SERVICE BULLETIN

M-1333

M1333: 2012-2013 VRSCDX MODELS LICENSE PLATE BRACKET MOUNTING (SAFETY RECALL CODE 0148)

Figure 1. License Plate Bracket (rear fender removed for clarity)

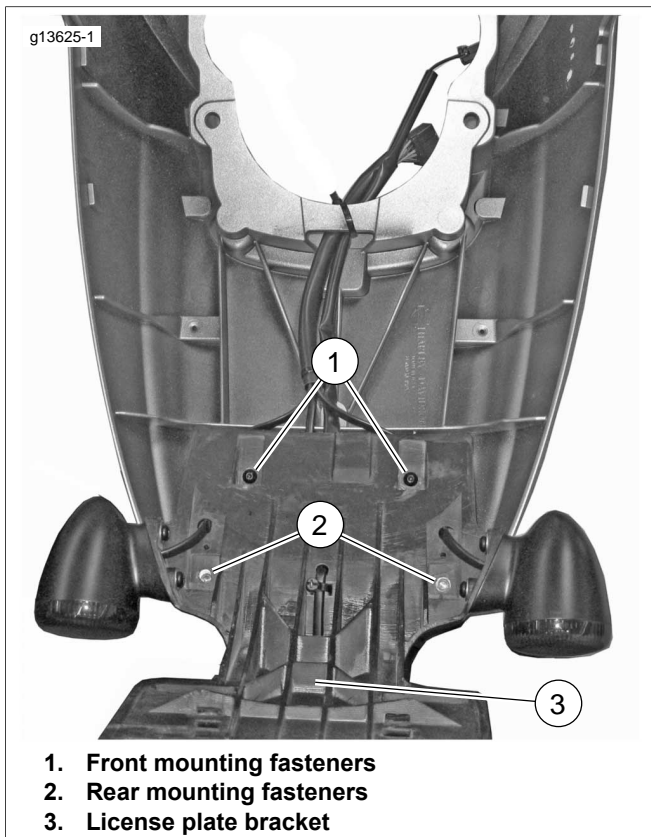
Harley-Davidson has determined that a condition affecting motor vehicle safety exists on all 2012 and certain 2013 VRSCDX model motorcycles. The License Plate Bracket Assembly may lose retention to the rear fender, allowing the bracket to contact the rear tire. Contact with the rear tire could rotate the license plate bracket, possibly damaging the rear brake line. This may affect rear brake performance.

2. See Figure 1. Remove the two rear mounting fasteners (2).
3. Clean fasteners.
4. Apply Loctite 243 Medium Strength Threadlocker and Sealant (blue) or equivalent.
5. Install fasteners in rear mounting holes. Tighten to 9.7-20.3 **in-lbs** (1.1-2.3 Nm).
6. Remove the two front mounting fasteners (1). Do not reuse fasteners.
7. Apply Loctite 243 Medium Strength Threadlocker and Sealant (blue) or equivalent to two fasteners from recall kit.
8. Install fasteners and washers from recall kit in front mounting holes. Tighten to 9.7-20.3 **in-lbs** (1.1-2.3 Nm).
